# **RESPONSES TO COMMENTS ON THE DRAFT ENVIRONMENTAL IMPACT REPORT**

## **SFPUC Alameda Creek Recapture Project Volume 3**

PLANNING DEPARTMENT  
 CASE NO. 2015-004827ENV  
 STATE CLEARINGHOUSE NO. 2015062072  
 JUNE 7, 2017

Re: **Responses to Comments on the Draft Environmental Impact Report for  
Case No. 2015-004827ENV, SFPUC Alameda Creek Recapture Project**

**Figure 11.5-1**

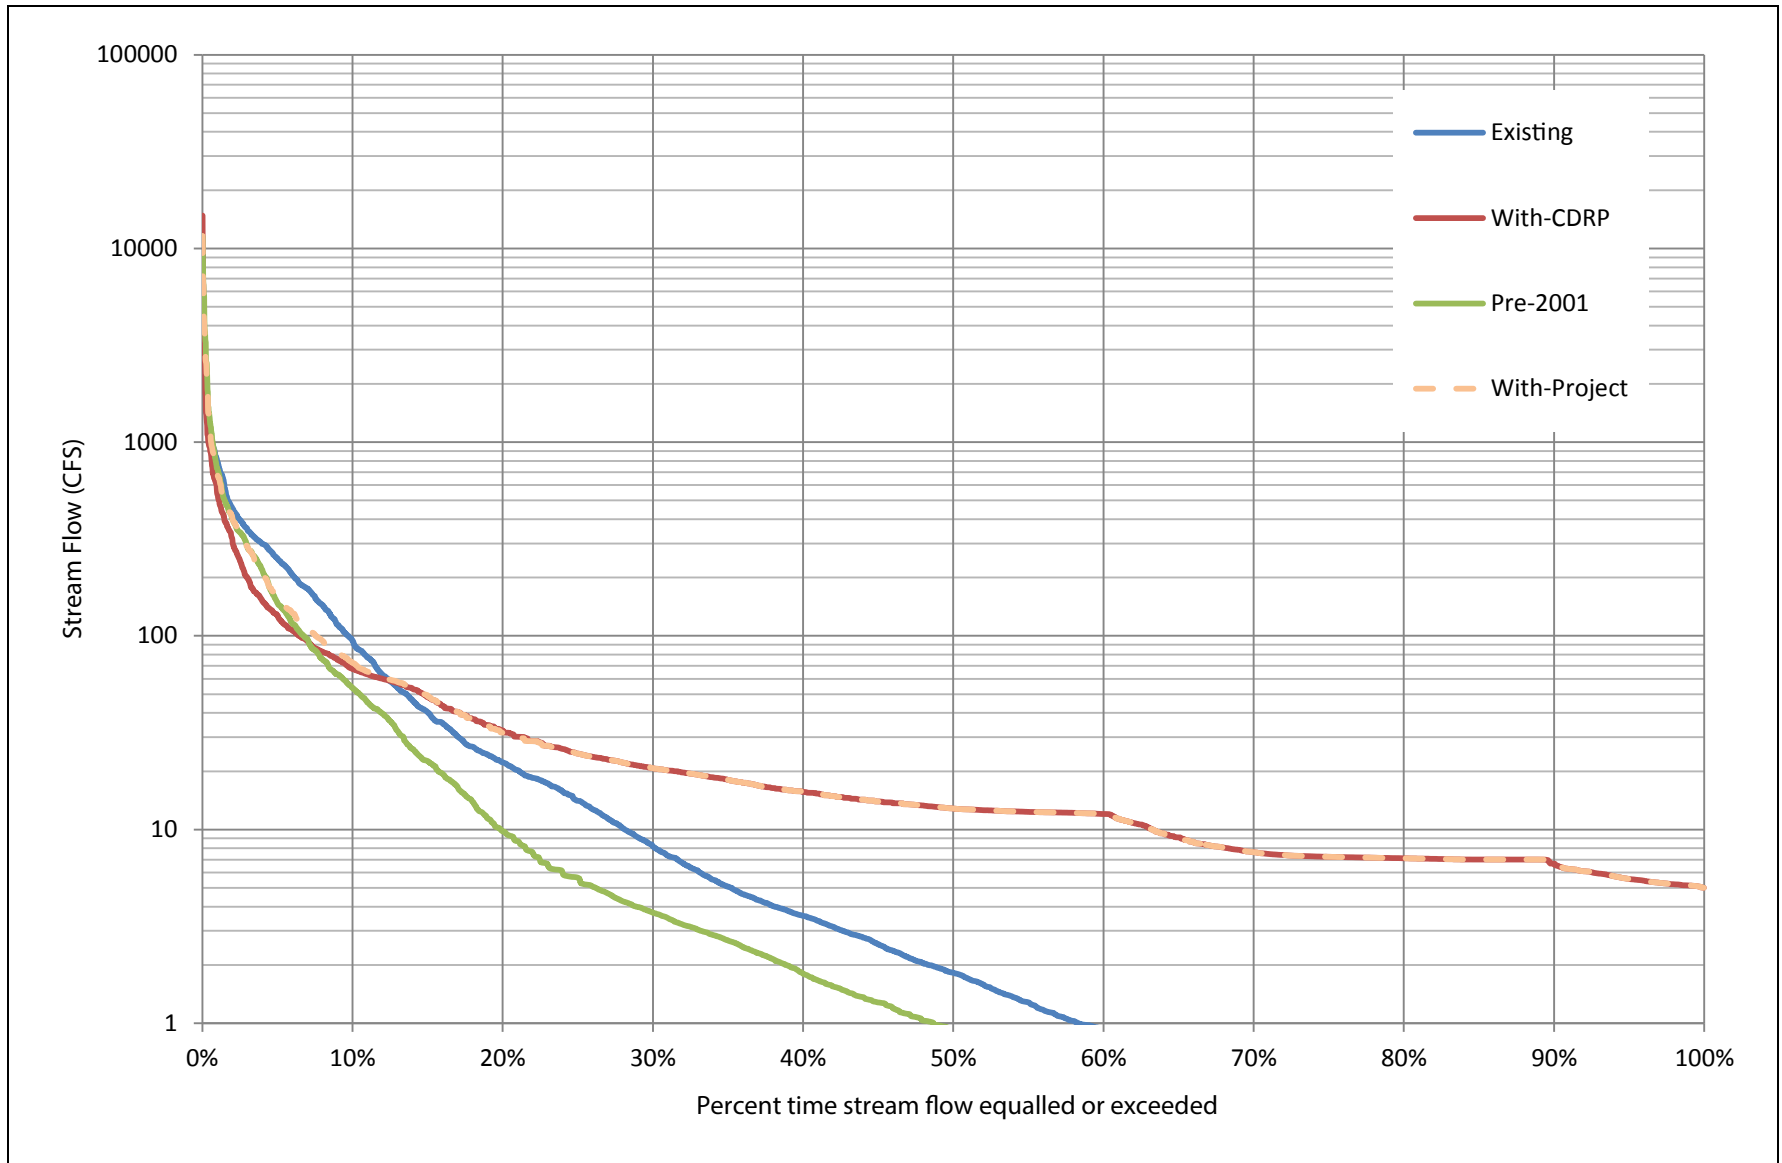
Comment A-NMFS-1 requests information on the number of days there is a surface water flow connection through the Sunol Valley to assist in assessing the ACRP's potential effects on steelhead migration and the duration of flows for seasonal rearing of juvenile steelhead in the Sunol Valley. The number of days of surface water flow connection through Sunol Valley is not stated explicitly in the EIR but can be deduced from information provided in the EIR itself and Appendix HYD1 (Figures 5.16-3, 5.16-4, 5.16-5 in the EIR, pp. 5.16-13 to 5.16-16, and Section 5.16.2.4, pp. 5.16-11 to 5.16-18 in Chapter 5; and Section 5.3, pp. 61 to 76; and Section 5.3, pp. 61 to 76, Section 6.2, pp. 80 to 98, and Figures HYD5-5, HYD5-6, HYD5-7, HYD6-3, HYD6-4 and HYD6-5, pp. 63, 64, 66, 86 to 88, in Appendix HYD1). The results of the analysis of when there is a surface water connection through the Sunol Valley are shown in **Table 5.11-1**. For there to be continuous flow through Sunol Valley, there would need to be flow at both Nodes 5 and 7 on the same day, regardless of the flow at Node 4. An explanation of how the results were arrived at is provided below.

Figure HYD5-5 in Appendix HYD1 (p. 63) shows flow-duration curves for pre-2001 conditions, existing conditions, and with-CDRP conditions at the Alameda Creek/Welch Creek confluence (Node 4). **Figure 11.5-1** shows the same information, but with the addition of a flow-duration curve for with-project conditions. The figure shows that on about 52 percent of the days under pre-2001 conditions and on about 42 percent of the days under existing conditions, Alameda Creek is dry, or almost dry, at the Welch Creek confluence; or conversely, as indicated in Table 11.5-1, there would flow in the creek on 48 percent of the days under pre-2001 conditions, and 58 percent of the days under existing conditions. Under pre-2001 conditions, the SFPUC operated Calaveras Reservoir in accordance with the SFPUC's pre-1914 appropriative water rights and continues to do so under existing conditions. Under both with-CDRP and with-project conditions, flow would continue past the Welch Creek confluence every day and the creek channel would never be dry. This is a result of the releases at Calaveras Reservoir and the bypasses at the Alameda Creek Diversion Dam that are a part of with-CDRP and with-project conditions.

Figure HYD5-6 in the Appendix HYD1 (p. 64) shows flow-duration curves for pre-2001 conditions, existing conditions, and with-CDRP conditions at a location on Alameda Creek just upstream of the San Antonio Creek confluence (Node 5). **Figure 11.5-2** shows the same information, but with the addition of a flow-duration curve for with-project conditions. In all four scenarios, pre-2001 conditions, existing conditions, with-CDRP conditions, and with-project conditions, flow in Alameda Creek at the San Antonio Creek confluence is less than it is at the Welch Creek confluence. This is because the condition of the streambed of Alameda Creek under all four scenarios is made up of permeable gravels downstream of the Welch Creek confluence in the alluvial deposits of Sunol Valley. Project construction and operation will not change this condition. As a result, surface water is lost under existing conditions, and will continue to be lost under with-project conditions, to the subsurface between the Welch Creek and San Antonio Creek confluences at a maximum rate of 17 cubic feet per second (cfs). Under pre-2001 conditions, Alameda Creek just upstream of the San Antonio Creek confluence was dry, or almost dry, about 82 percent of the time; under existing conditions it is dry, or almost dry, about 75 percent of the time. Stated conversely, this portion of the channel has continuous flow 7 percent more often under existing conditions than under conditions before 2001 when the Calaveras Reservoir operated at full capacity, reflecting the inability of the SFPUC to fully utilize the entire storage volume of Calaveras Reservoir under the 2001 DSOD order. Under with-CDRP and with-project conditions, the creek would be dry, or almost dry, about 64 percent of the time. Thus, in the reach of Alameda Creek upstream of the San Antonio Creek confluence, continuous flow occurred about 18 percent of the time under pre-2001 conditions, under existing conditions it occurs about 25 percent, of the time, and under with-CDRP and with-project conditions it would occur about 36 percent of the time.

**Revised Figure 1-1**

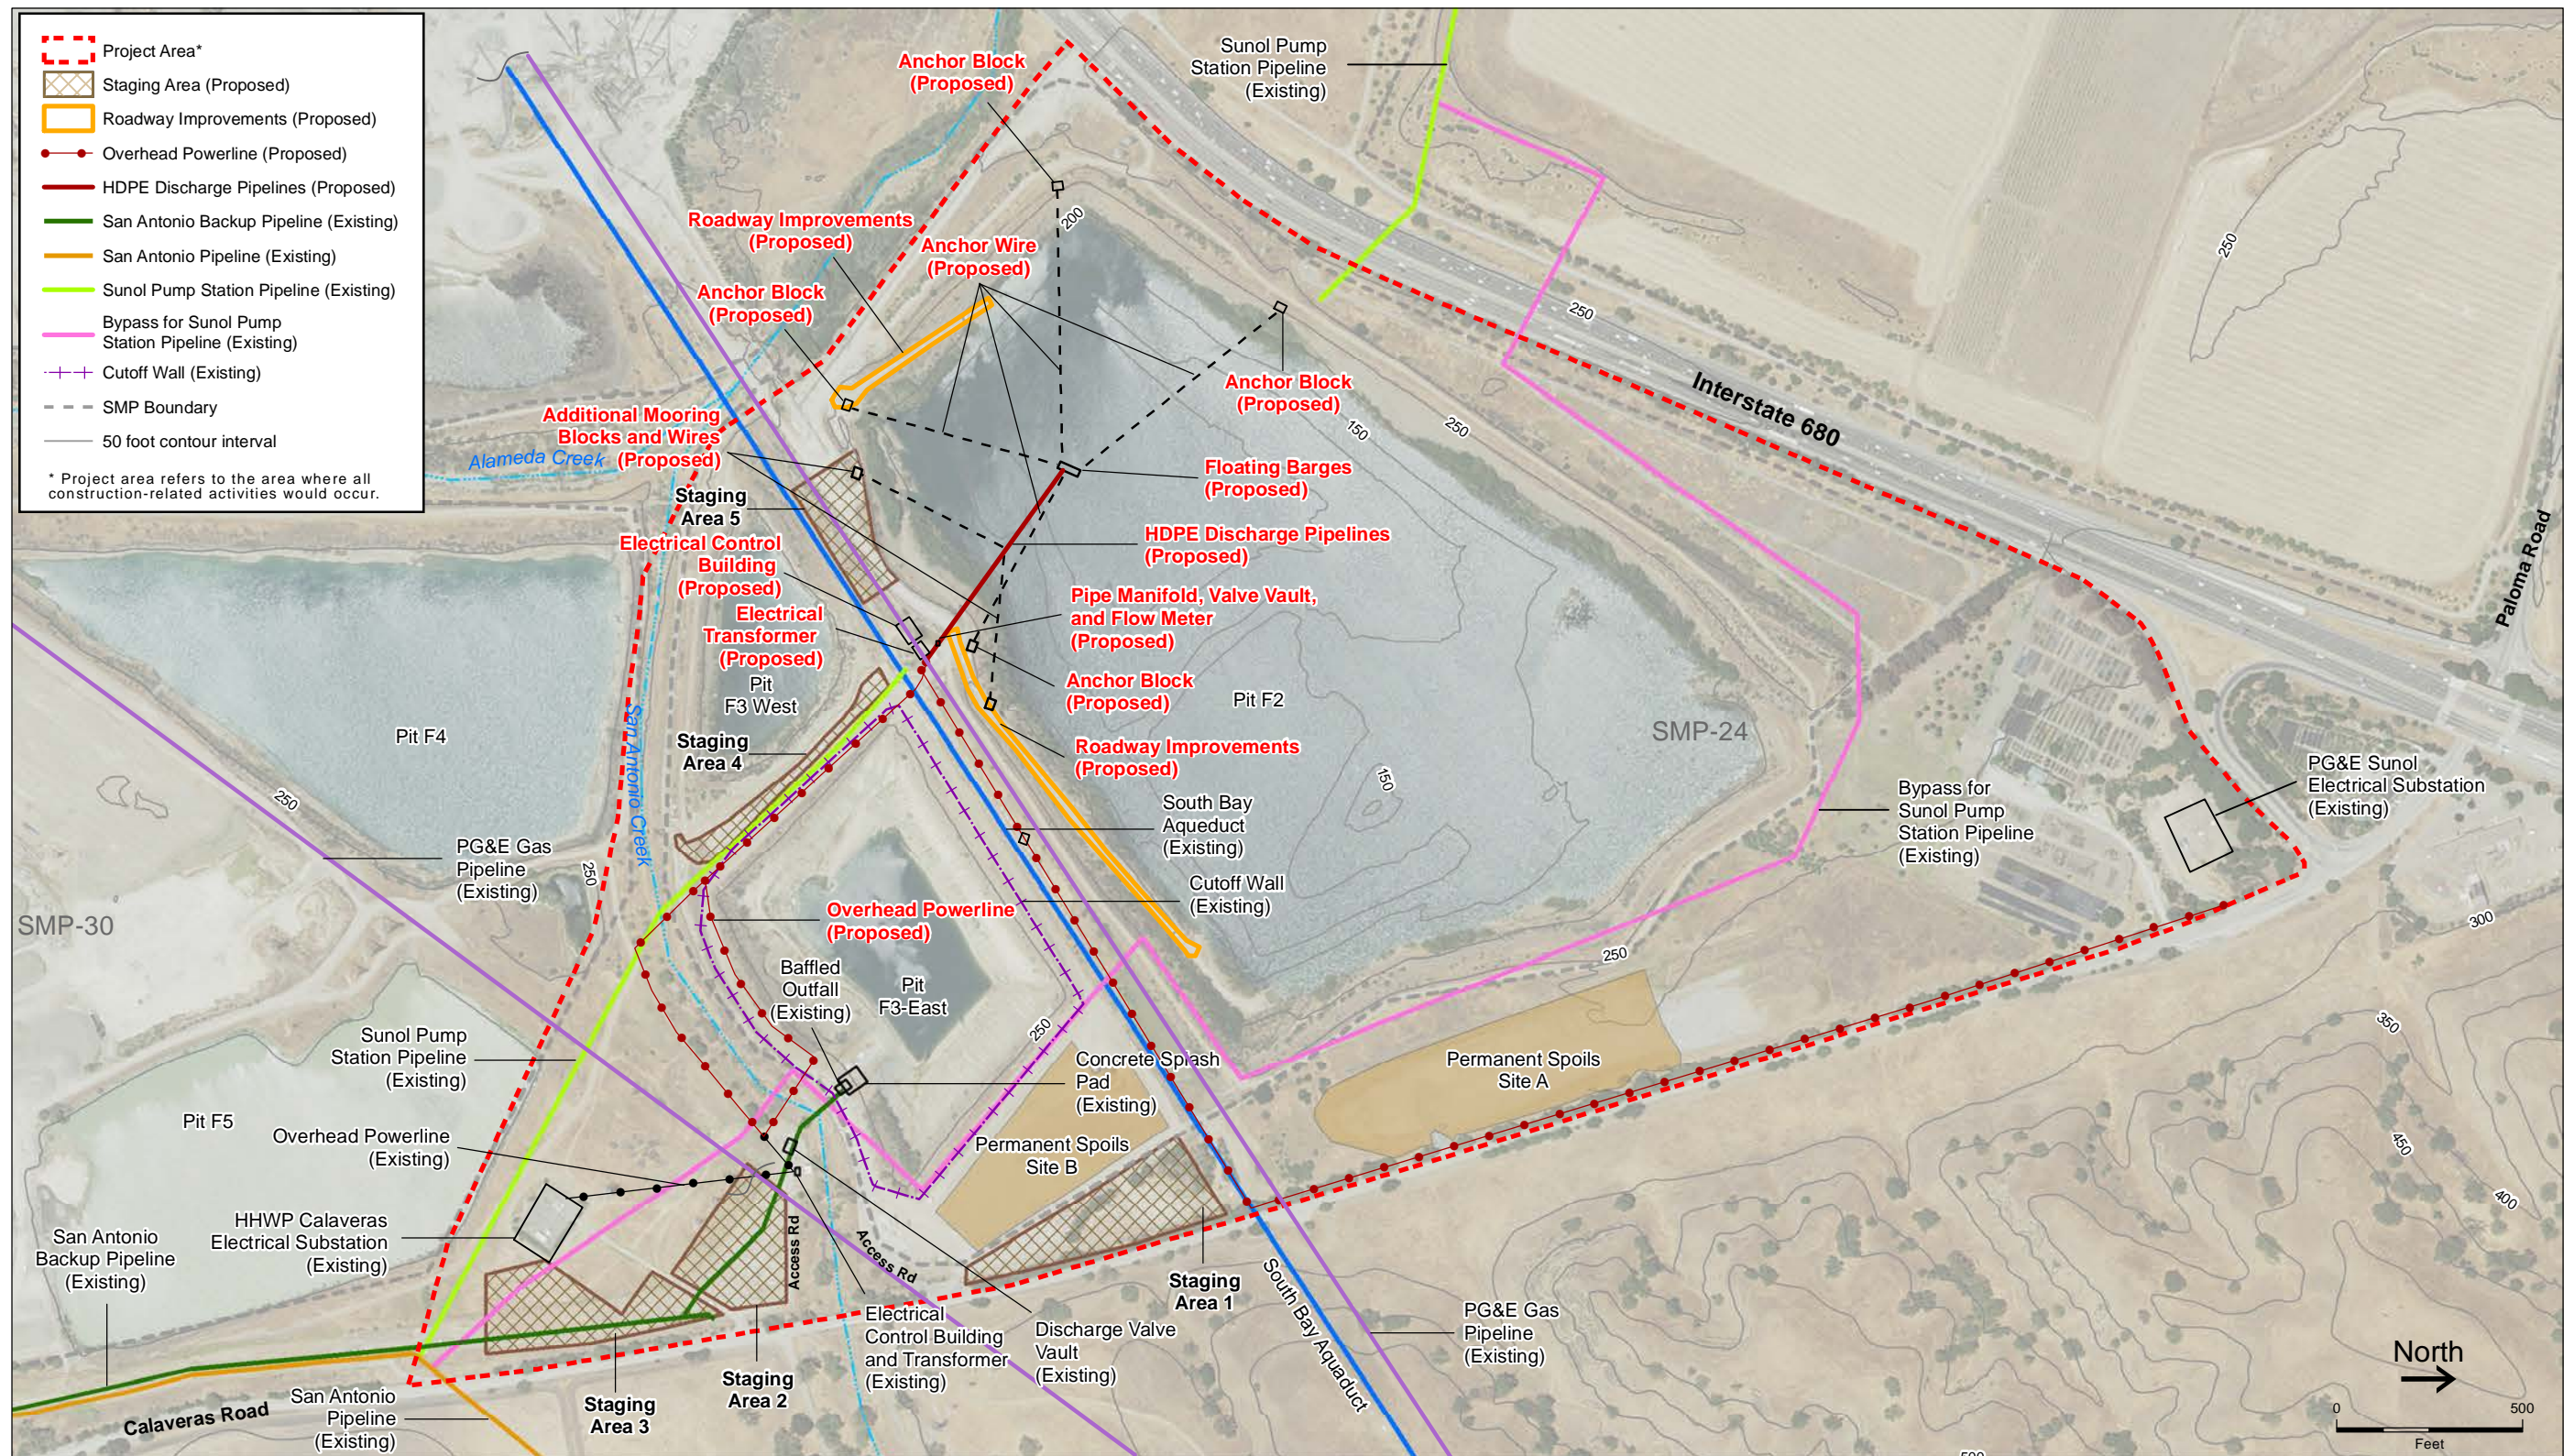
- 
- f. **The DEIR cumulative impacts do not include effects of cutoff walls.** Figure 1-1 of the DEIR displays existing cutoff walls around Pit F2, which were installed to minimize seepage of Alameda Creek surface water into the groundwater basin and into Pit F2. The figure also displays proposed future cutoff walls around sections of Pit F6. Installation of this future cutoff wall will likely provide additional protection from surface streamflow losses to the Sunol groundwater basin. The hydrologic analysis must be refined to include the proposed cutoff wall, and any associated changes in streamflow loss rate to determine cumulative impacts and adequately model future streamflow conditions through this reach (CEQA Guidelines §§ 15065(a)(3), 15130). (Robert Shaver, General Manager, Alameda County Water District, January 30, 2017, A-ACWD2-10)
-

In response to this comment, Figure 1-1 and Figure 3-2 in the EIR (identical figures) have been revised to remove the proposed cutoff wall because it currently does not exist. This revision does not change the analysis or conclusions of the EIR.

As discussed in Response HY-9, Figure 1-1, page 1-3 has been revised to remove the proposed cutoff wall because it currently does not exist, as shown on page 12-3. See Revised Figure 1-1.
